Subject: Response to the Referenced Technical Incompleteness Determination - Non-Asterisked Items, Waste Isolation Pilot Plant Hazardous Waste Facility Permit Number: NM4890139088-TSDF

Response to Technical Incompleteness Determination

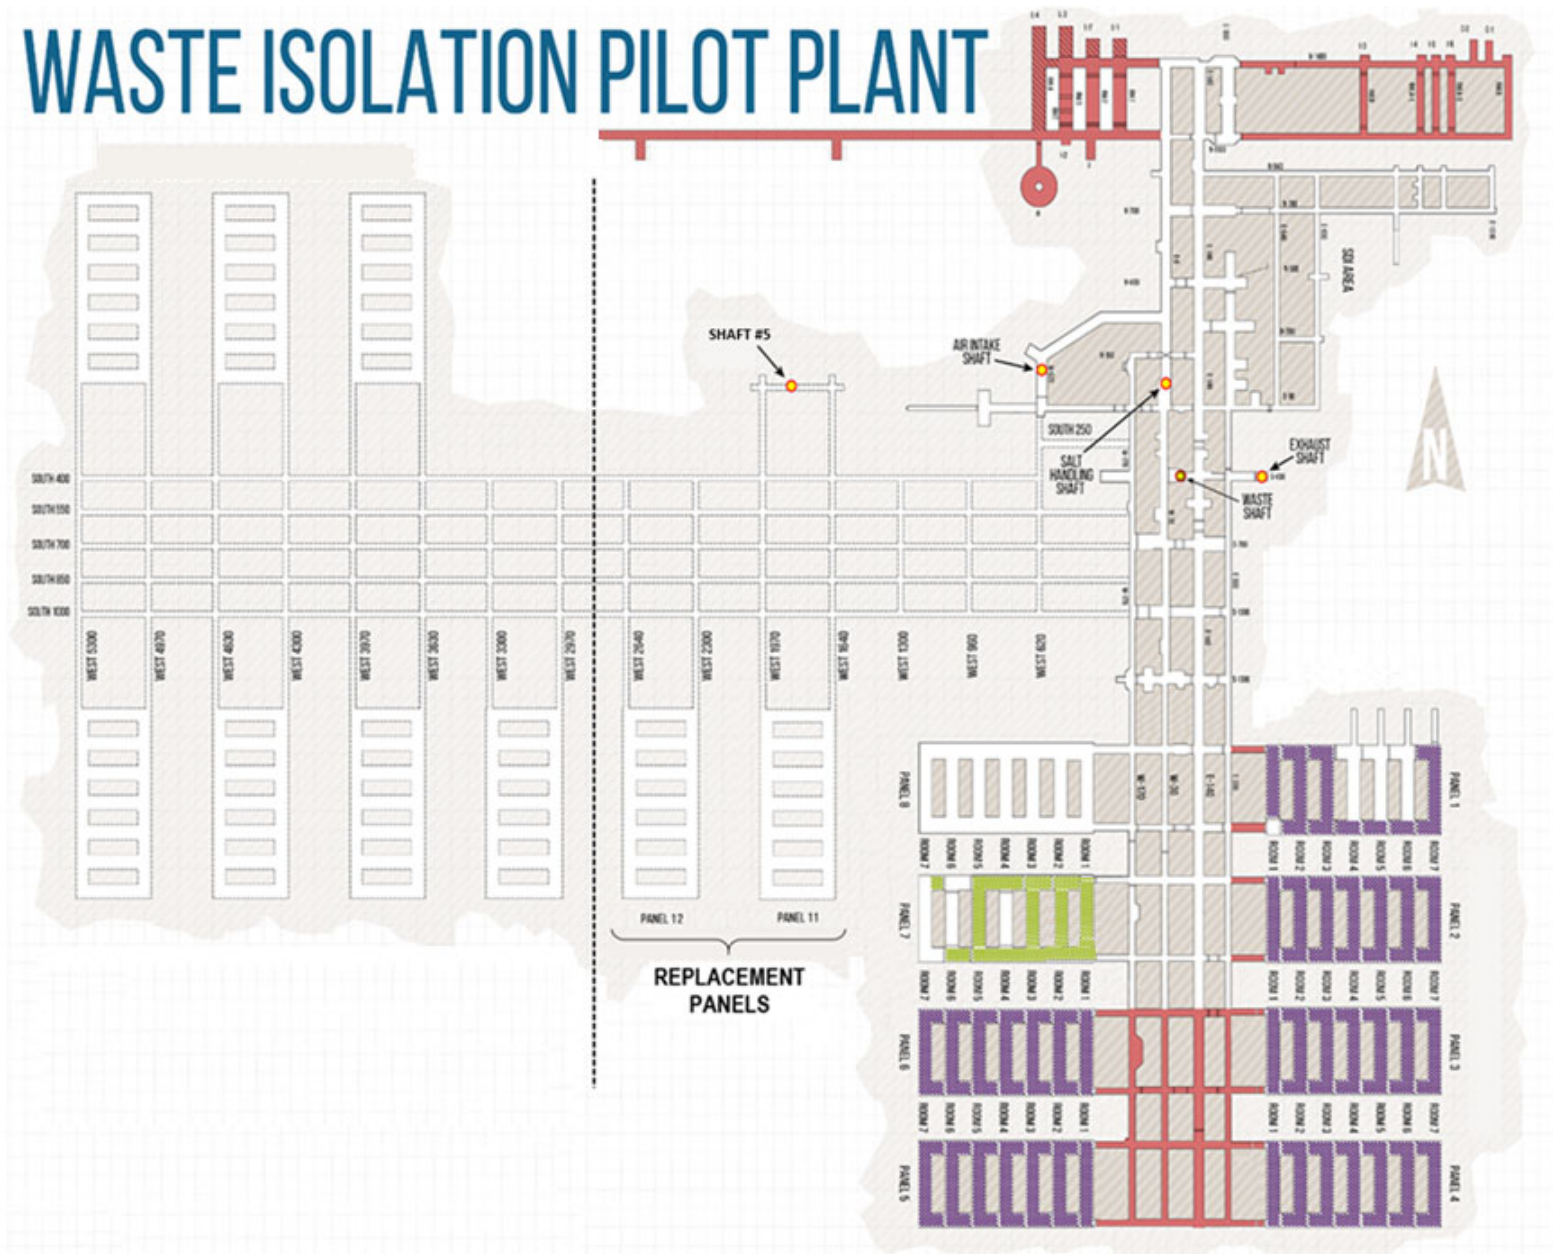
3. Please provide a schematic of the conceptual plan for the anticipated final facility footprint.

RESPONSE: The Permittees did not propose a facility footprint beyond replacement Panels 11 and 12 in the updated Redline Strikeout (RLSO). The Permittees object to any inclusion or reference to a final facility footprint beyond Panels 11 and 12 in the Administrative Record for Renewal, since a conceptual anticipated final facility footprint first requires *National Environmental Policy Act* (NEPA) action pursuant to 10 CFR 1021.210, *DOE decisionmaking*.

The Permittees provided a layout for the underground repository in the updated RLSO. This layout includes Panels 11 and 12. The Permittees are only requesting authorization for construction and use of Panels 11 and 12. However, Panels 11 and 12 will not accommodate the LWA total volume capacity. Additional panels beyond Panels 11 and 12 would be subject to a future Class 3 Permit Modification Request (PMR).

The U.S. Department of Energy (DOE) is planning NEPA action to evaluate continued operation for disposing defense TRU waste, up to the LWA volume capacity limit, which includes panels beyond Panels 11 and 12. A conceptual plan with an anticipated final facility footprint may be available depending upon the NEPA decision. However, in the interest of providing the NMED with information, the Permittees provide the following pre-decisional conceptual illustration of a footprint as an example:
